Project	IEEE 802.16 Broadband Wireless Access Working Group < http://ieee802.org/16 >	
Title	[Terminal Assisted QoS support]	
Date Submitted	[2004-03-05]	
Source(s)	Park, Yunsang Joo, Panyuh Koo, Changhoi Samsung Electronics 416, Maetan-3dong, Youngtong-gu Suwon-si, Gyeonggi-do, Korea	Voice: [82-31-279-5370] Fax: [82-31-279-5515] yunsang.park@samsung.com chkoo@samsung.com panyuh@samsung.com
Re:	IEEE 802.16d Terminal assisted QoS support	
Abstract	This contribution contains a proposal that helps to support QoS requirement of services by providing each mobile terminal's unique status, such as channel status and internal memory usage status, to the corresponding network.	
Purpose	Propose to IEEE 802.16 d or e ad-hoc group	
Notice	This document has been prepared to assist IEEE 802.16. It is offered as a basis for discussion and is not binding on the contributing individual(s) or organization(s). The material in this document is subject to change in form and content after further study. The contributor(s) reserve(s) the right to add, amend or withdraw material contained herein.

Terminal assisted QoS

Figure 23—Bandwidth request header format

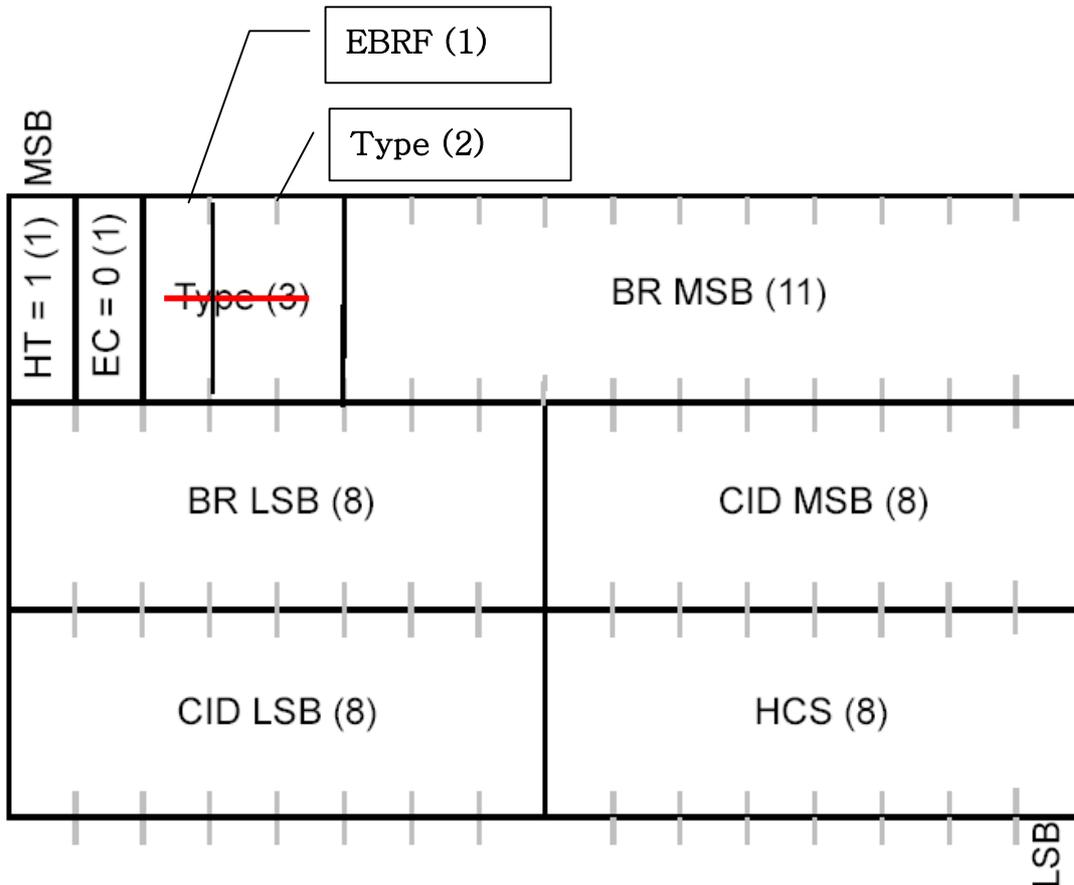
[Modify the Figure 23 in page 56, IEEE802.16-REVd/D3-2004]
